Volare' Carburetors, LLC
125 Piedmont Avenue
Gibsonville, N.C. 27249, USA

Service Bulletin: SB-11
Revision: Original
Date: June 17th, 2009

SUBJECT – UNAPPROVED REPAIR PRACTICE

Figure 1: Peened Example

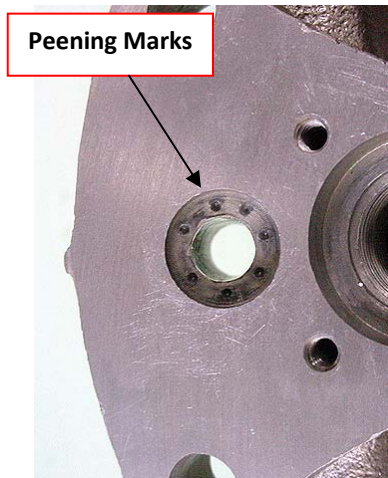
Fact: Peening the area around the bearing bore causes the mixture shaft loads to bear on small, upset metal projections which will wear away quickly. Thus, the repair will be short lived. Additionally, an airtight seal between the mixture control shaft and the throttle body is imperative. If the seal is compromised and outside (ambient) air enters the float bowl, an excessively rich fuel/air mixture will occur. The rough surface can prevent the necessary airtight seal.

Examples of unauthorized peening of the mixture shaft bore are shown in Figures 1 & 2 on page 2, (Fig. 1 bottom view, Fig. 2 top view). Figure 3 shows a properly repaired mixture shaft bore. The factory can make such repairs. If the mixture shaft bearing bore has inadequate metal remaining, contact Volare' to have the bore properly repaired.

4. **Compliance:** At the next carburetor disassembly or sooner if an excessively rich mixture is experienced:
 - a. Examine the mixture shaft bearing bore and area around it. If unauthorized repairs have been accomplished, the mixture shaft bearing bore is oversized, or the sealing surfaces are damaged, send the carburetor to Volare for repair.
